Mega Denim Ltd.

Observations

Discrepancies between drawings and on site condition

3 **Observation: Production Building**

Bracing layout

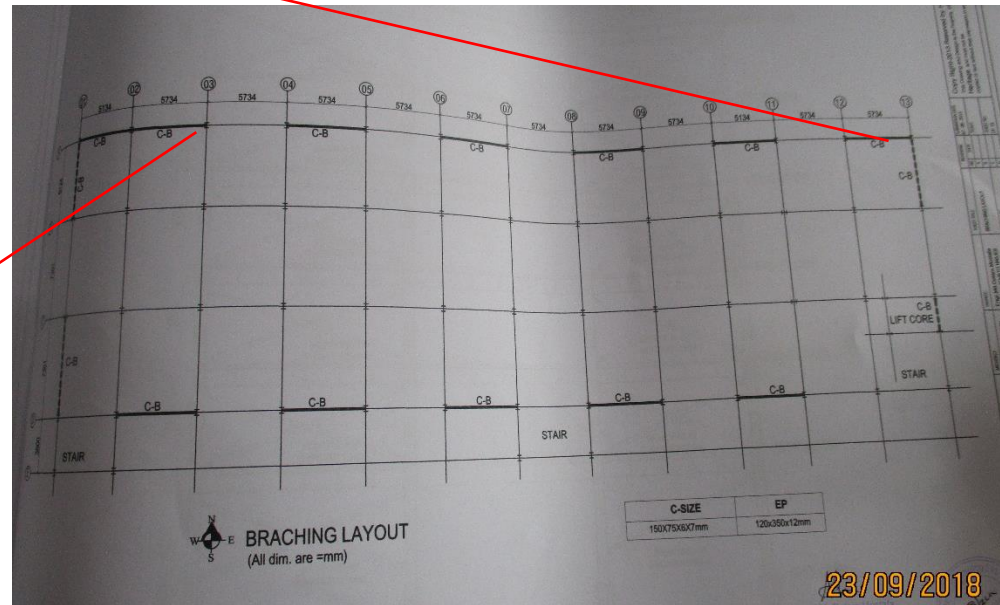
**Bracings are not installed as per
bracing layout**

Vertical Bracing missing

Vertical Bracing missing

Bracings were not installed as per bracing layout. Bracing was missing at several location on 2nd, 3rd and Ground floor.
